SUNDRY NOTICES AND REPORTS ON WELLS
Do not use this form for proposals to drill or to re-enter an abandoned well. Use form 3160-3 (APD) for such proposals.

8. Well Name and No.
HITCHCOCK B 1

MARBOB ENERGY CORPORATION PROPOSES TO PLUG AND ABANDON THIS WELL AS FOLLOWS:

**** BLM REVISED ** BLM REVISED ** BLM REVISED ** BLM REVISED ** BLM REVISED ****

Hitchcock B No. 1
 1980' FNL & 1980' FWL
 Sec 27 - T16S - R27E
 API No. 30-015-00571
 Marbob Energy Corp
 Eddy County, NM

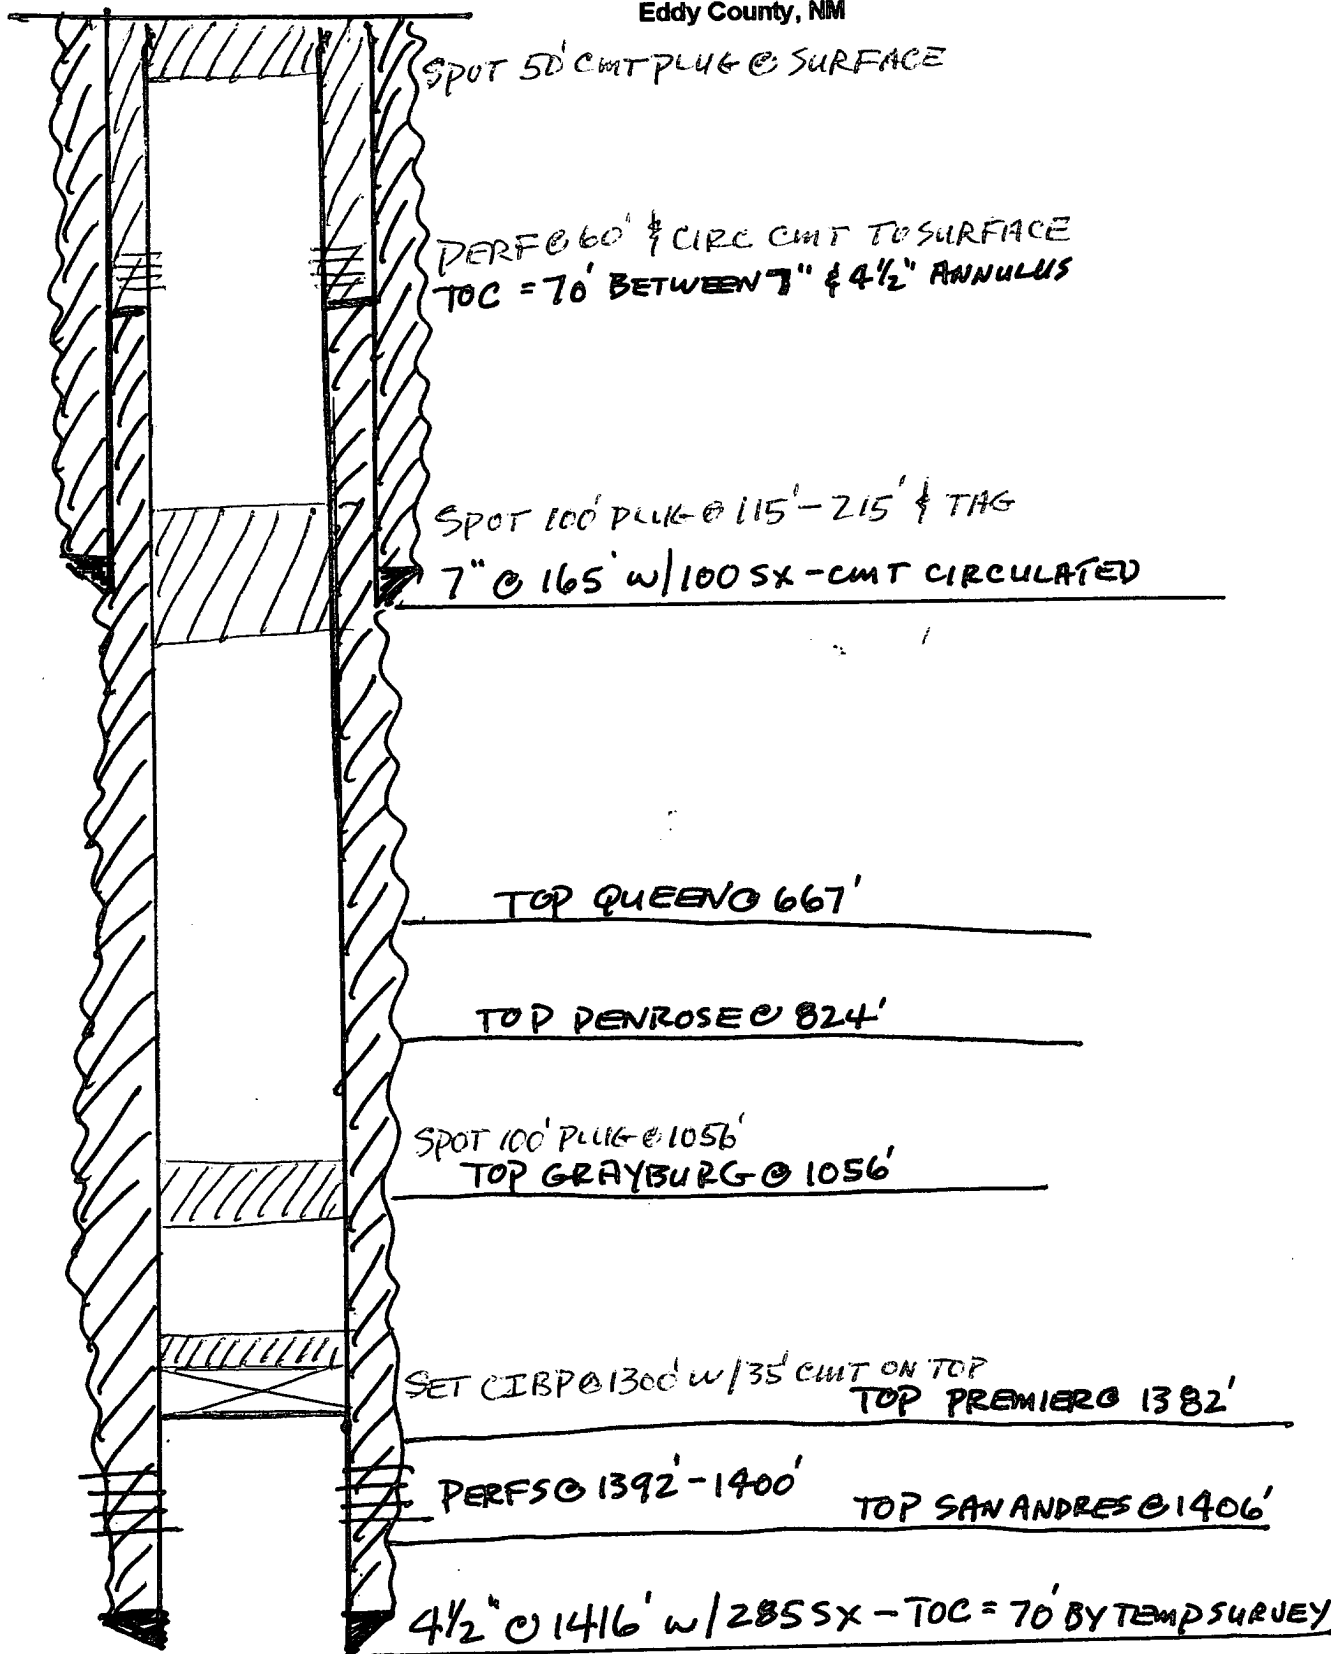
1. POOH W/ RODS & TUBING
 - OK 2. SET 4 1/2" CIBP @ 1300' (PERF 1392' - 1400')
 - OK 3. SPOT 100' PLUG @ 1056'
 4. ~~PERF @ 215', SQUEEZE 100' CMT, WOC, TAG~~ ← FROM WELL RECORDS BOTH STRINGS CIRCULATED AT THIS POINT, NO NEED TO PERF HERE (SEE ATTACHED)
 - OK 5. PERF @ 60', CIRC CMT TO SURFACE
 - OK 6. CUT OFF WELL HEAD, INSTALL DRY HOLE MARKER
- and SPOT 50' CMT PLUG @ SURFACE

RECOMMENDED PROCEDURE IN RED

NO SALT ZONES FROM WELL RECORDS
